Revision to HP2023_0246

CERTIFICATE OF APPROPRIATENESS

Property: 713 E 5th 1/2 Street, Lot 1, Block 1, Freeland Subdivision. The property includes a 3,605 SF two-story house under construction on a 6,250 SF (50' x 125') interior vacant lot.

Proposal: Revision to HP2023_0246

Approved Front Elevation – December 2023

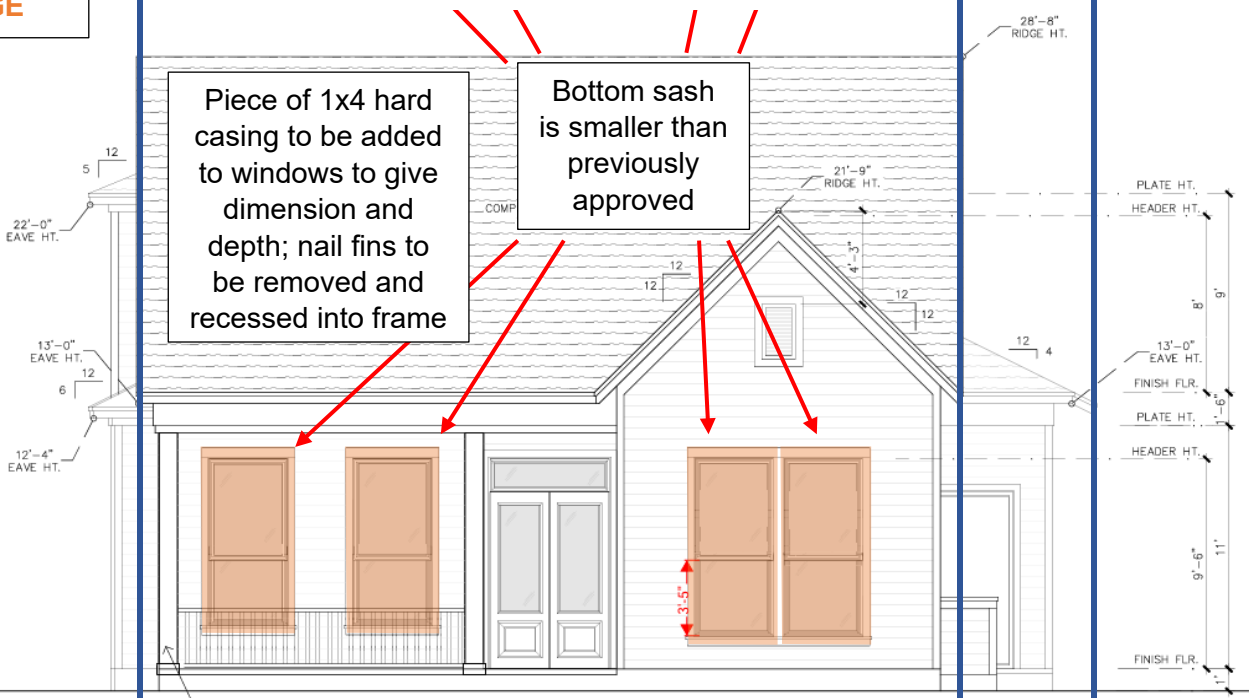
Piece of 1x4 hard casing to be added to windows to give dimension and depth; nail fins to be removed and recessed into frame

Bottom sash is smaller than previously approved
